HAMMAM AL ALIL DIVISION TRAINING  
CENTER  
MOSUL, IRAQ

**SIGIR PA-09-174**  
**JANUARY 7, 2010**

SUBJECT: Report on the Hammam Al Alil Division Training Center, Mosul, Iraq  
(SIGIR Report Number PA-09-174)

Figure 4. Multi-purpose small arms range layout (Courtesy of USACE)

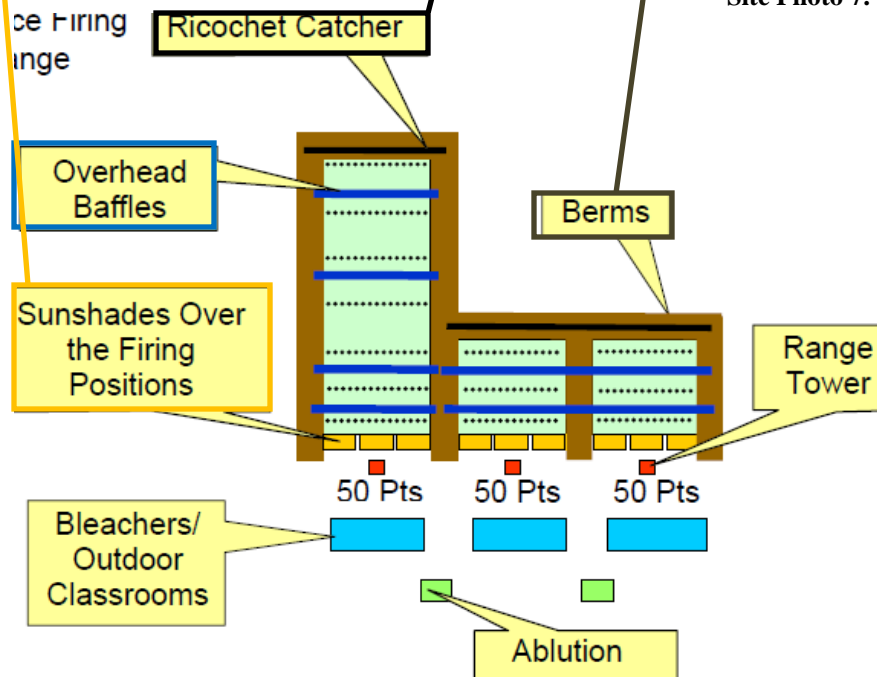
The SOW required the construction and installation of overhead baffles between the firing positions and the terminal end of the range (Figure 4). Overhead baffles were designed to contain all bullets fired from a prone or kneeling position. Also, the overhead baffles were designed to contain shots that would otherwise travel over the berm.

Due to the descoping of the overhead baffles, the multi-purpose small arms range was no longer considered a fully contained range. The GRN Mosul Area Office documentation did not address the status change of the range from a fully contained range<sup>6</sup> to a non-contained range<sup>7</sup>. In addition, the documentation did not address the safety concerns of removing the overhead baffles or the impact on public safety.

**Response:** On 1 Dec 2009 The Mosul Resident Office provided SIGIR documentation showing the chronology of events concerning the construction status of range baffles and the customer’s decision to remove them. In addition, the contractor’s program manager stated that the Iraqis, the end users, didn’t see a need for the baffles. The 30 foot berm at the terminating end of the range serves as the primary backstop. Further, the facility is located 24 kilometers south of Mosul in an isolated and sparsely populated area so the potential for collateral damage or injury is minimal.

**Response:** Concur. The customer and the end user (Division Training Center Personnel) were aware of the baffle construction problems and concurred with the baffle removal. As stated earlier, the range is located in an isolated and sparsely populated area and has a 30 foot berm that serves as the backstop. However if the customer, MNSTC-I, is willing to support and resource the effort, Gulf Region District will petition a safety study.
